UNITED STATES PATENT AND TRADEMARK OFFICE

APPLICATION NO.	FILING DATE	FIRST NAMED INVENTOR	ATTORNEY DOCKET NO.	CONFIRMATION NO.
10/535,646	05/20/2005	James Fraser	BTW-094US	9673
959 7590 05/15/2007 LAHIVE & COCKFIELD, LLP ONE POST OFFICE SQUARE BOSTON, MA 02109-2127			EXAMINER PINKNEY, DAWAYNE	
			ART UNIT 2873	PAPER NUMBER
			MAIL DATE 05/15/2007	DELIVERY MODE PAPER

Office Action Summary

DETAILED ACTION

**Fig. 1**

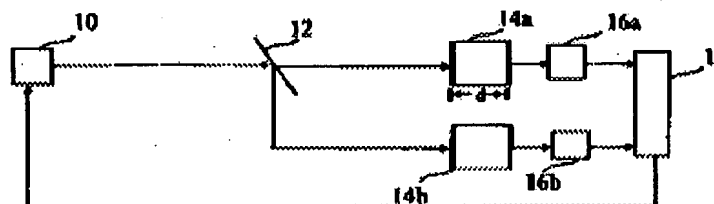
Regarding **claim 17**, Colbourne teaches, a wavelength locker according to claim 16, wherein the input and output faces are substantially flat and lie in substantially parallel planes (surfaces of 14a in Fig. 1).
